**GS# 104-215 Jones Hall Interior Renovations
Mississippi University for Women**

Addendum No. 3

SHEET **PD103**

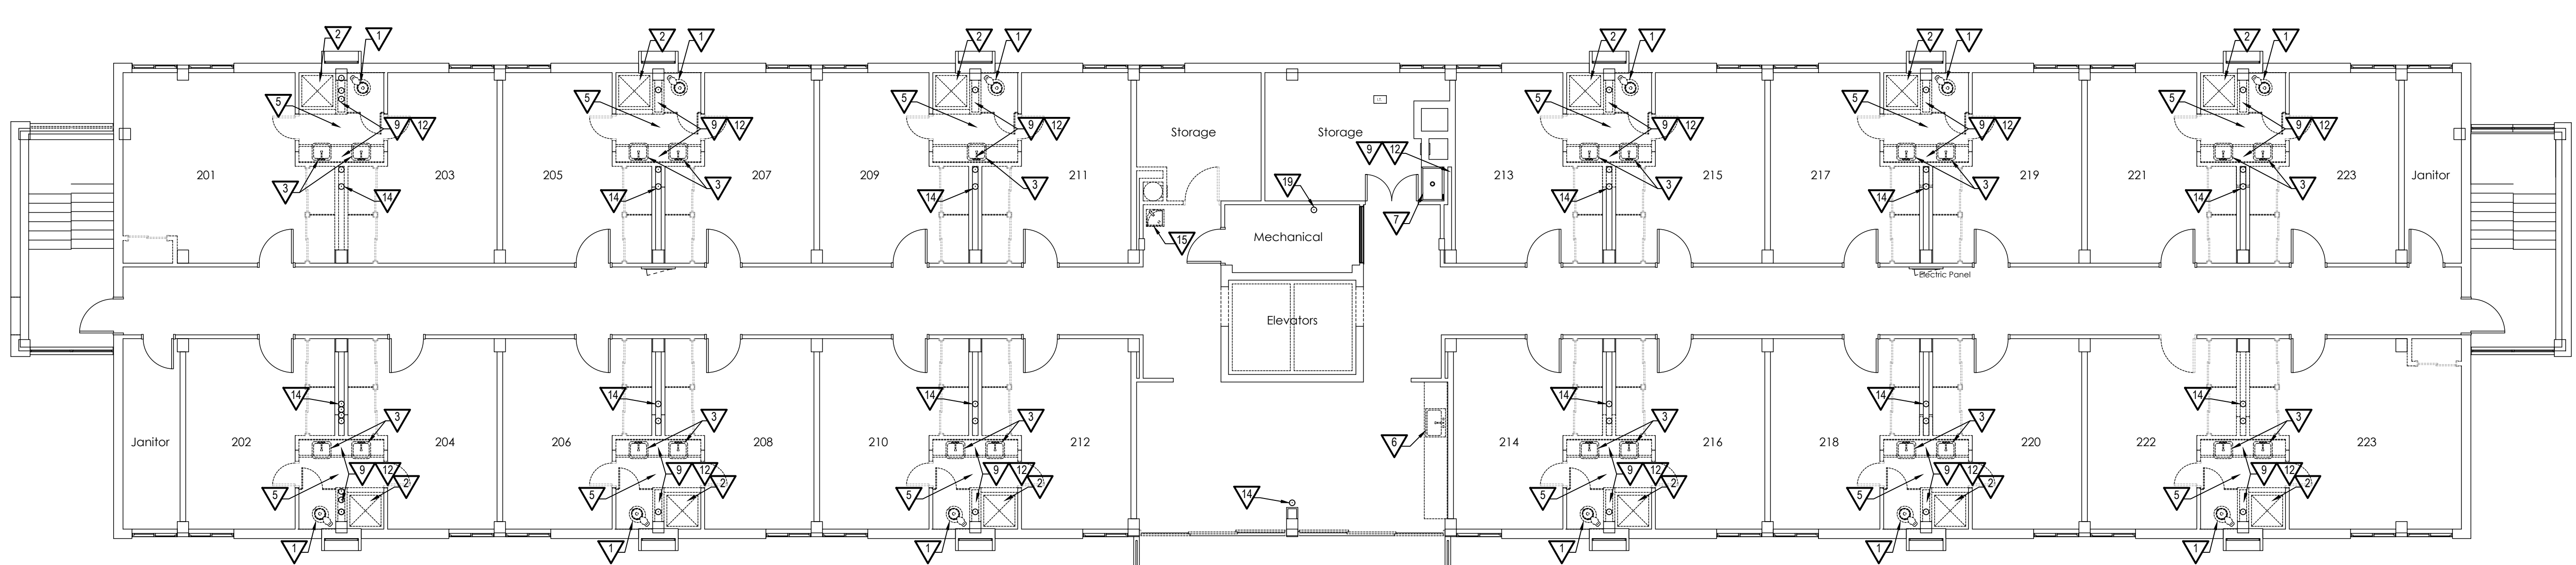
- e. A600: see attached full Opening Schedule provided in addition to typical information.
- f. Revise Sheet PD103 and replace with attached Sheet PD103. Revisions included updating note 12 on the demolition sheet to clarify extents of sanitary vent demolition.

- 10 REMOVE EXISTING HOSE BIBB.
 - 11 REMOVE EXISTING ICE MAKER WATER CONNECTION.
 - 12 REMOVE ALL EXISTING SANITARY SEWER WASTE/VENT PIPING ABOVE GRADE. CUT EXISTING VENT PIPING APPROXIMATELY 6" BELOW ROOF DECK. REUSE EXISTING PENETRATION FOR NEW SYSTEM. SAWCUT FLOOR AND CAP ALL BELOW GRADE PIPING CONNECTION BELOW THE FIRST FLOOR SLAB. PIPING BELOW THE BUILDING SLAB TO BE ABANDONED IN PLACE.

SHEET **E003**

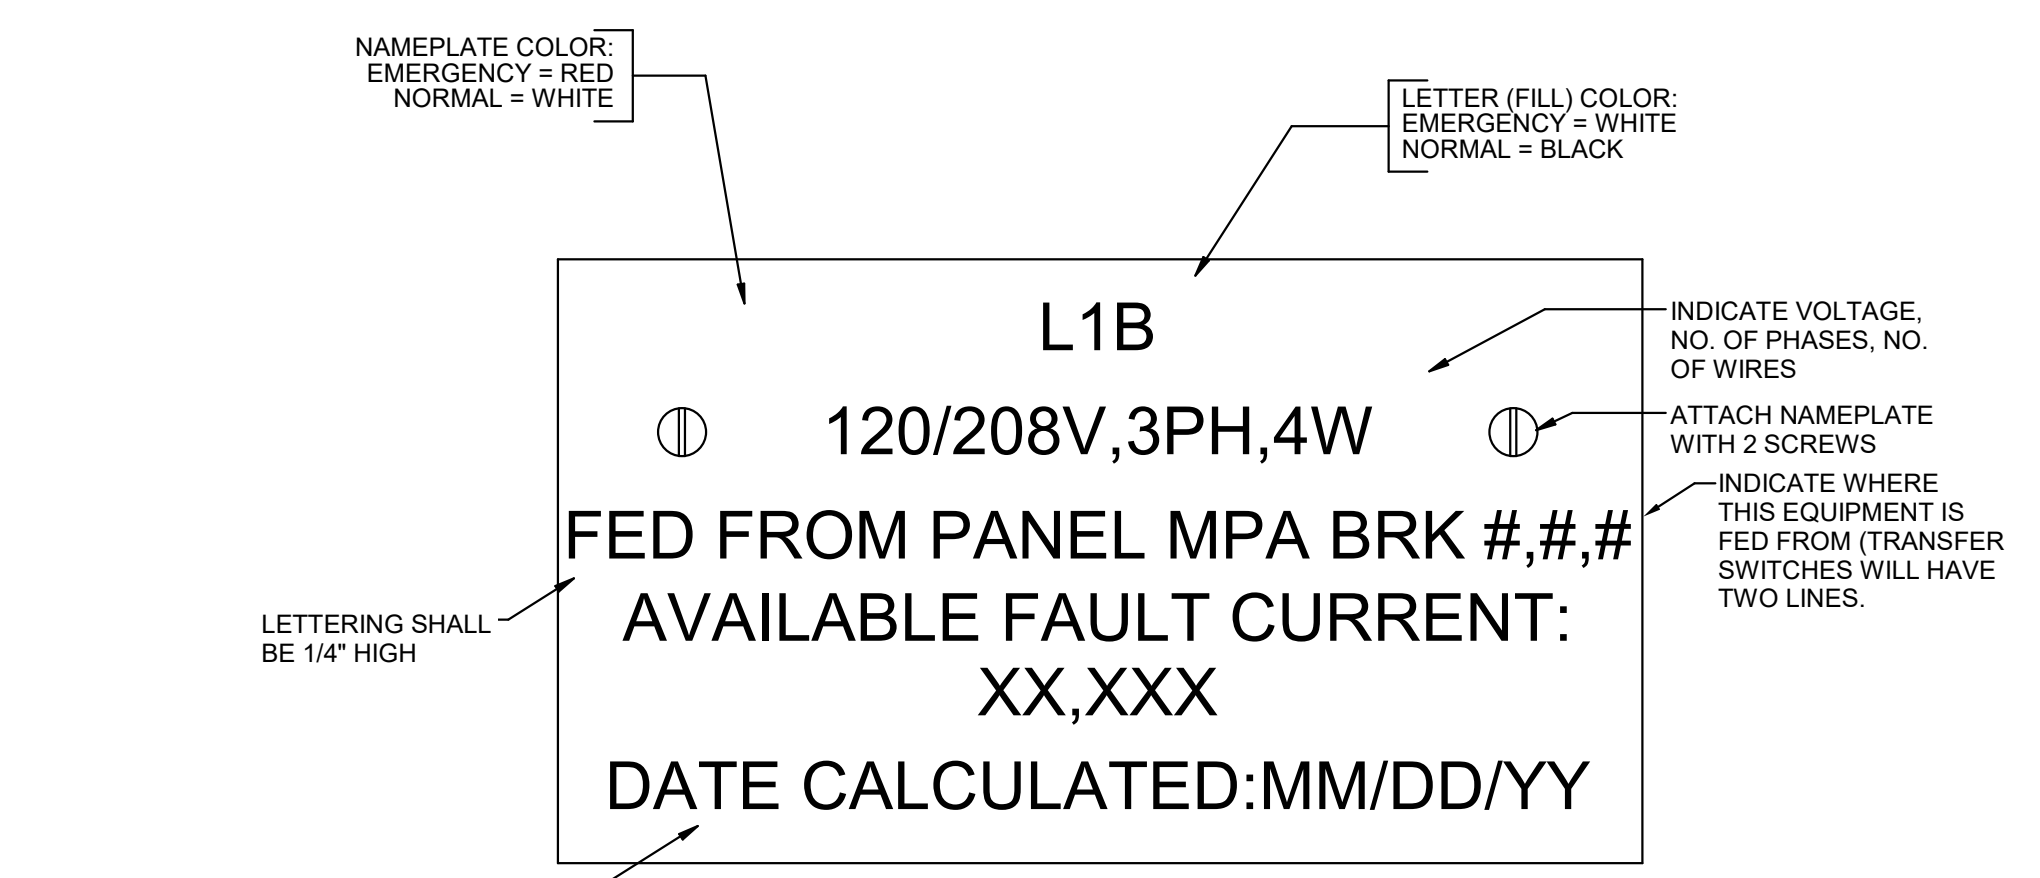
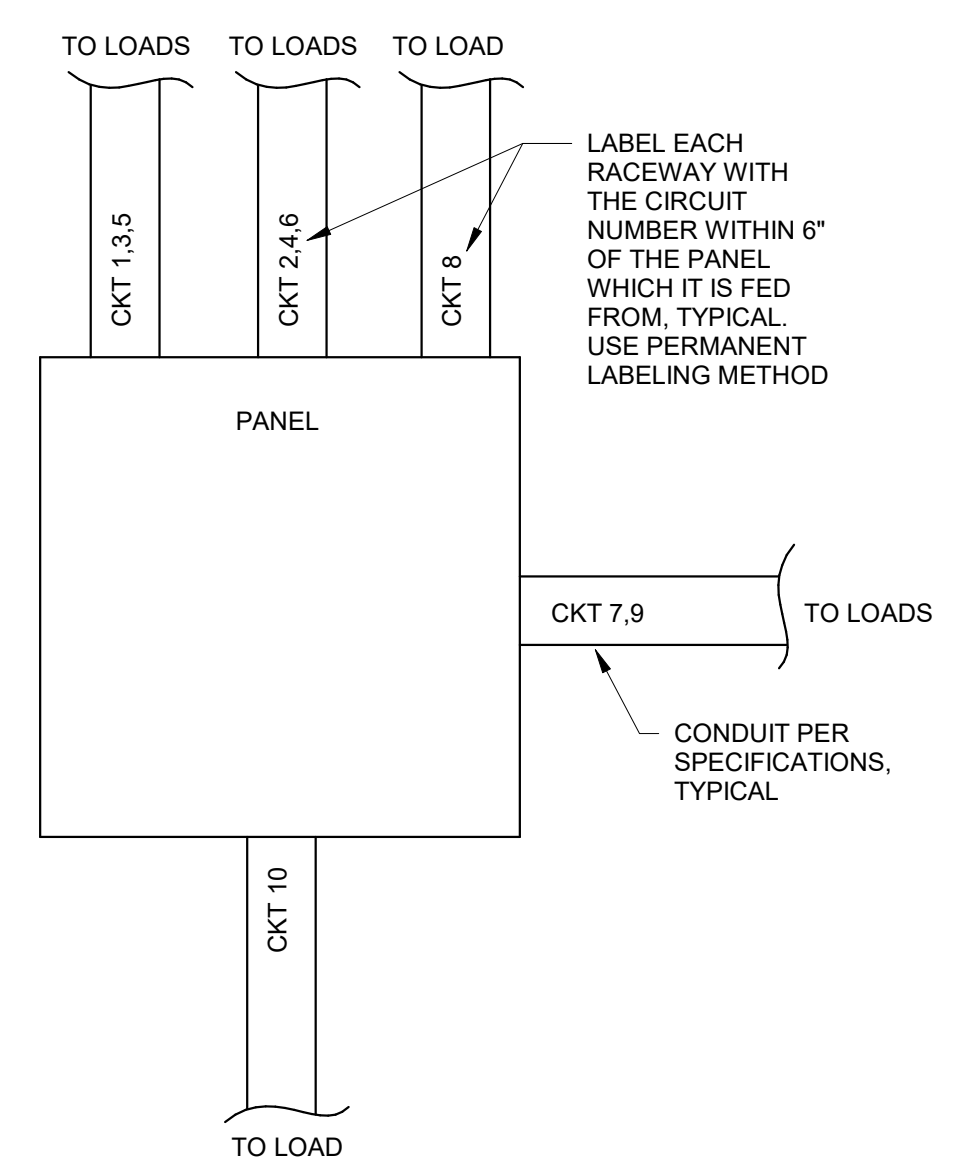
- g. Revise Sheet E003 and replace with attached Sheet E003. Revisions included updating grounding and AHU details.
- h. Revise Sheet E006 and replace with attached Sheet E006. Revisions included updating panel L-1C to show the elevator cab lights and exhaust fan circuits. Added more spaces to the panel.

SHEET **E009**

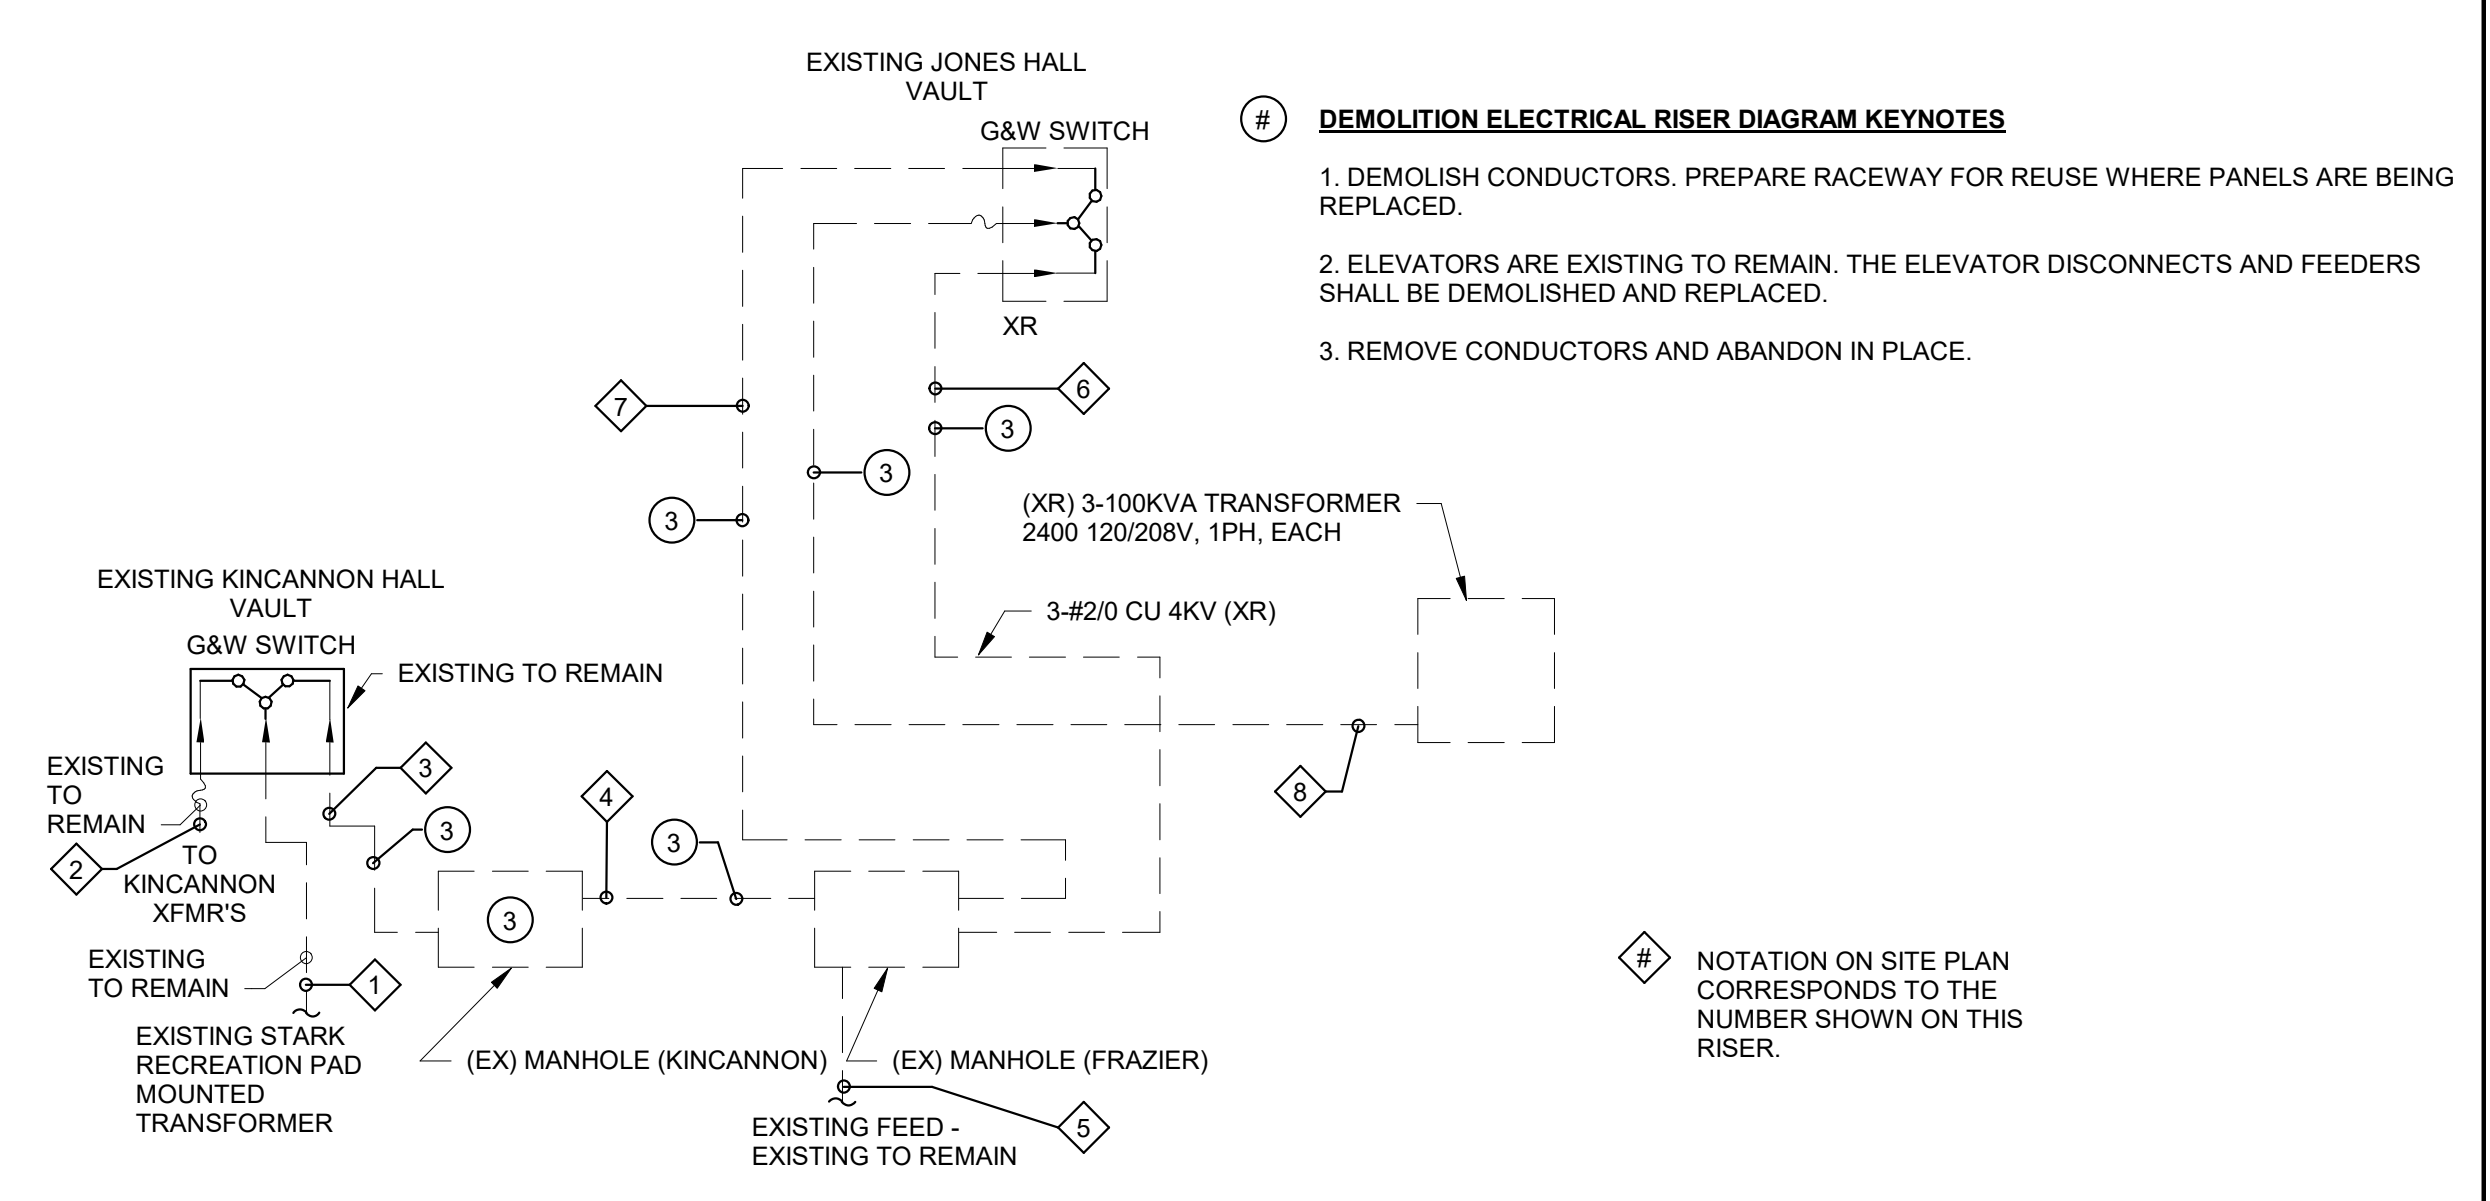
- k. Revise Sheet E009 and replace with attached Sheet E009. Revisions included adding more notes to the partial riser diagram to provide clarity of keynotes.
